DEPARTMENT OF
**PLANNING &
ZONING**

SUBJECT: CONCEPT REVIEW OF 724 NORTH PATRICK STREET
BAR CASE# 2026-00054

BAR2026-00054
Parker-Gray
724, 726, & 728 North Patrick Street

Figure 1: Buildings at 728 N Patrick and 1006-1008 Madison to be demolished

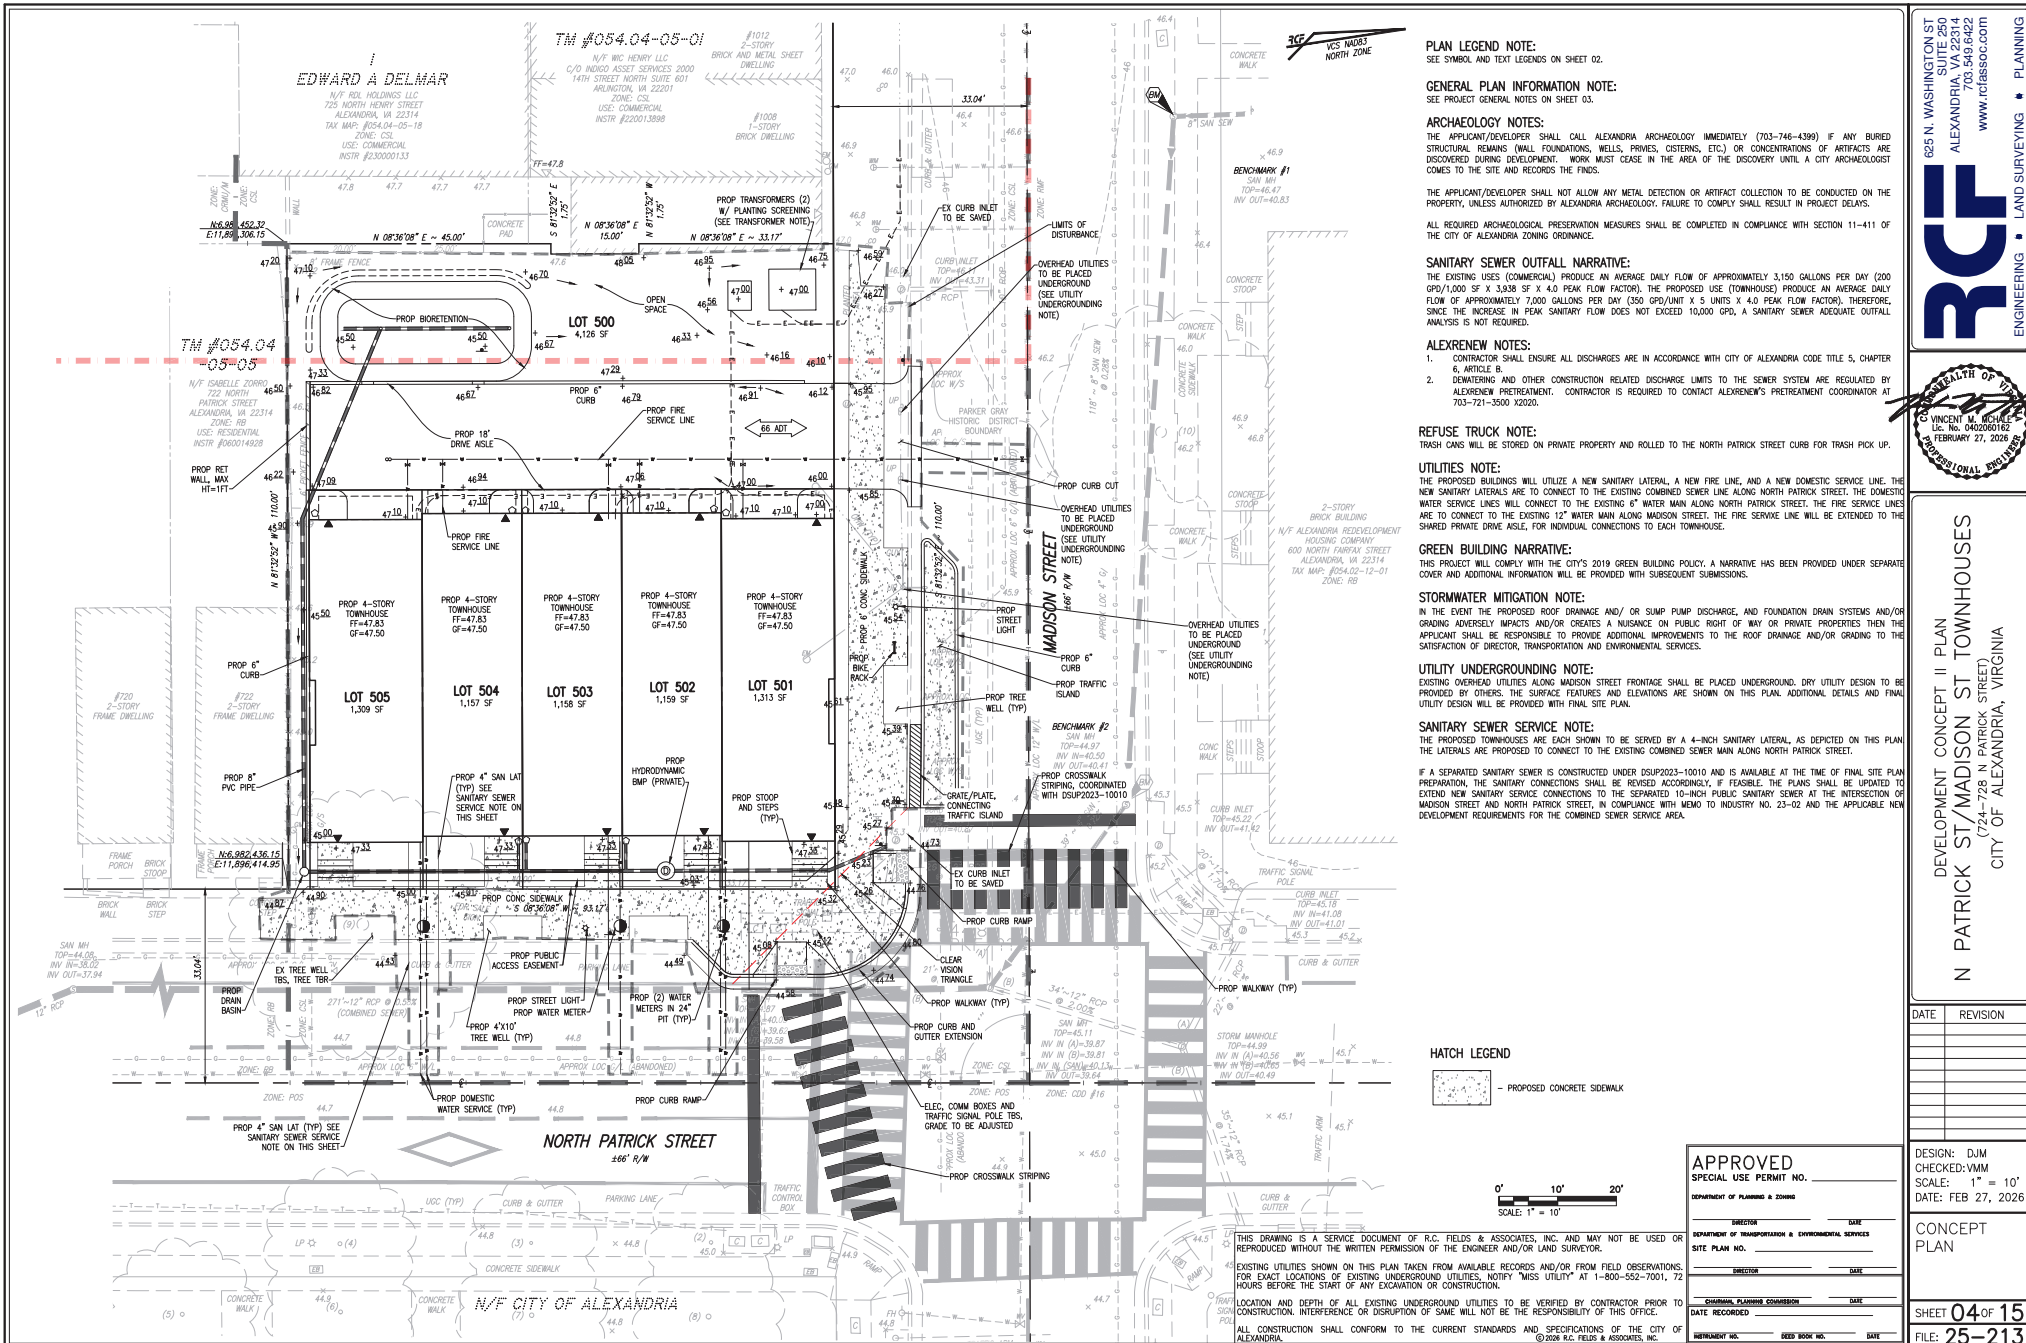
The applicant is proposing to build five new townhomes in place of the empty lot and existing buildings at 728 North Patrick and 1002 Madison Street. A separate Permit to Demolish will be required to raze the two existing buildings on the project site. The applicant is not requesting that permit at this time but since the project is contingent upon the removal of these two buildings it is helpful for the Board to provide feedback on this proposal at this stage of the project. The building at 728 North Patrick dates from the 1930s, staff has not been able to determine a more precise date so it is impossible to determine if it is an Early building or not. The building currently houses a hair salon but according to records it has housed a number of uses and originally held a small residence and dance hall. The building has a gabled roof with concrete blocks on the south side and brick on the north and east elevations. Staff supports the demolition of this building because it is from the mid-twentieth century and is not of unique construction or design.

The building at 1002 Madison Street is a one story with a small second floor section building clad in concrete block on the east and south sides. On the north side of the building the concrete blocks have been covered with vinyl siding. This light industrial building was built sometime between 1941 and 1958 is of a typical construction for industrial buildings from the mid-twentieth century. For these reasons, staff supports the proposed demolition of this building.

REAR / WEST ELEVATION - PRIVATE AISLE STREETSCAPE
SCALE: 1/4" = 1'-0"

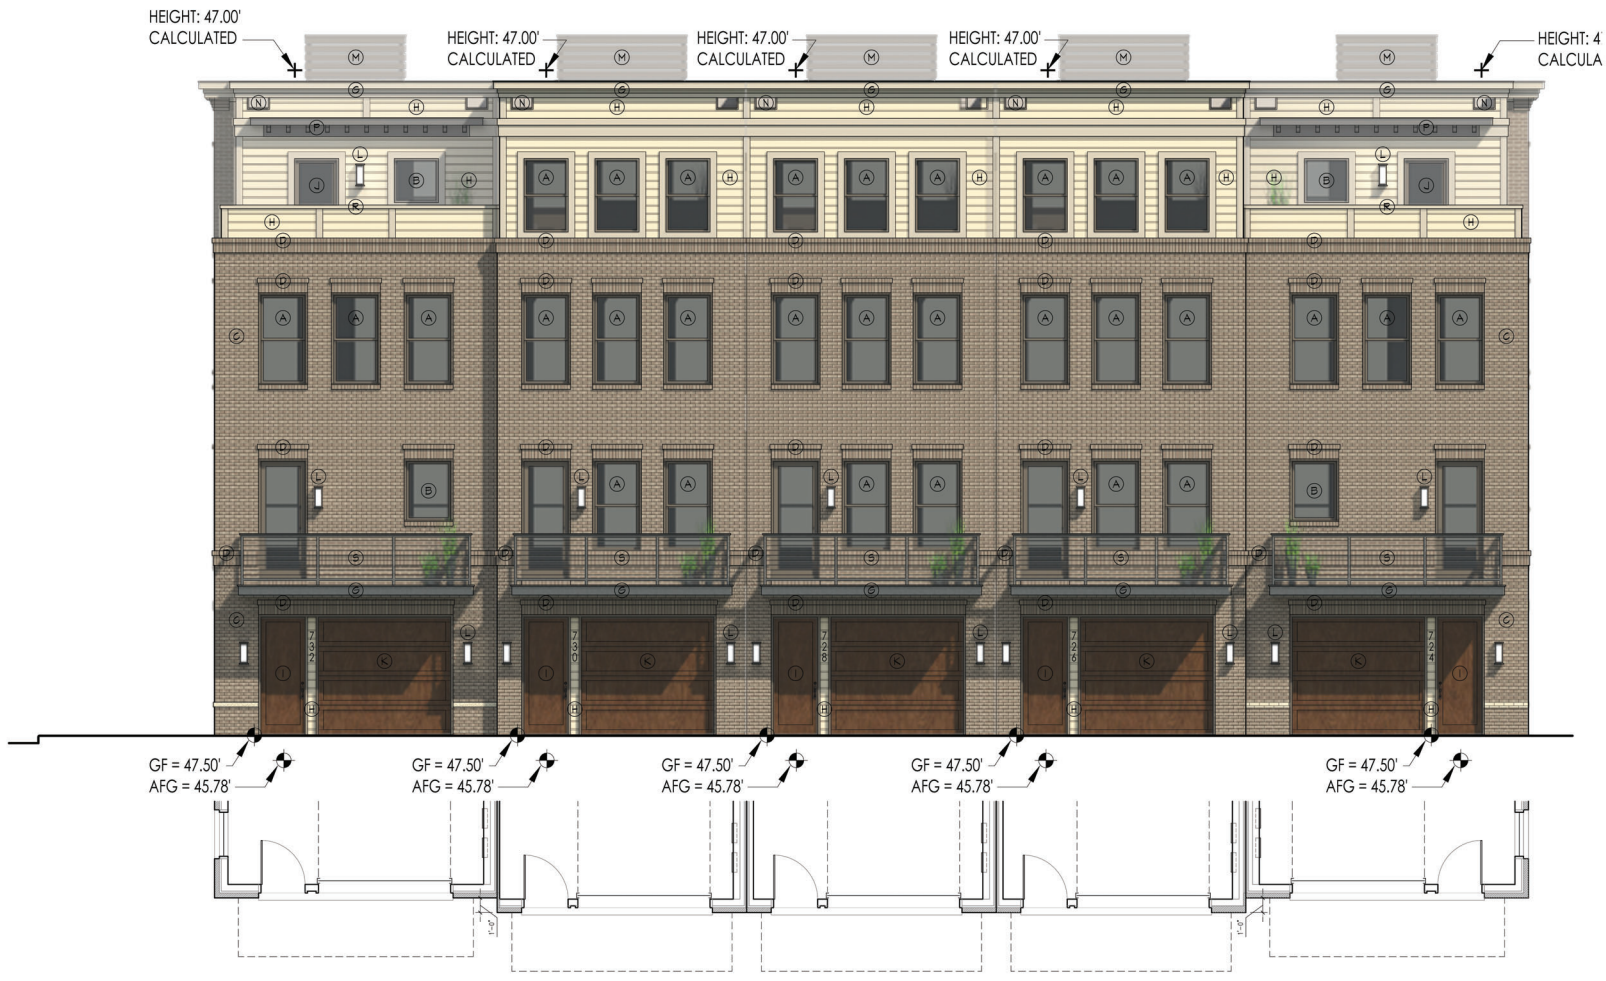
At the east elevation, the windows in the tower elements are in an asymmetrical configuration with a grouping of two and a single window over the door. At the middle three units, the second and third floors have arched brick window openings at the second and third floors. A decorative brick belt course extends across all five units at the second floor window sill and the same belt course extends around the tower elements at the fourth floor window sill.

- Typically in historic residential design there is a hierarchy of windows between the floors with the upper level windows smaller than those on the lower levels. The applicant should consider including a similar hierarchy in the proposed design.

- The proposed design includes a horizontal precast band that aligns with the first floor window sills. This creates a water table at the base of the building which is similar to details found on historic masonry buildings. The applicant should study the proportions of water tables on historic structures to ensure compatibility of the proposed detail with this context.
- The tower elements at the north and south ends of the building feature a decorative cornice that extends across the east elevation and wraps around to return at the inside corner of the west side of the building. This cornice is cut off at the roof deck facing east. This creates an awkward detail at this outside corner. The applicant should consider extending this corner along the inside of the towers.
